Product: TRP 1250 / TRP 9250

**SUBJECT: Power Off problem**

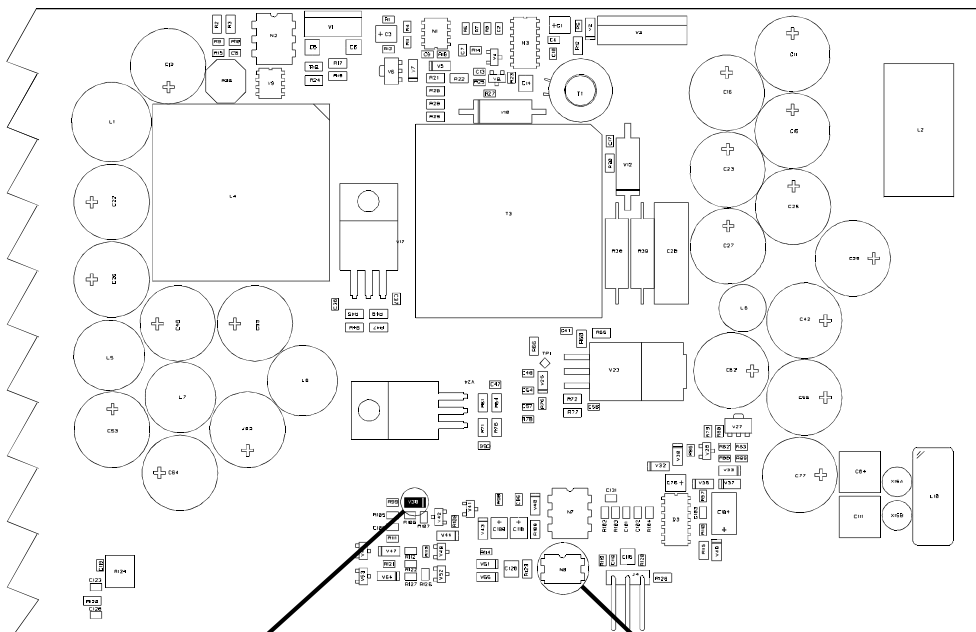
Place a 470 pF ceramic capacitor on top of the housing of N8. Solder it to the two pins as indicated below:
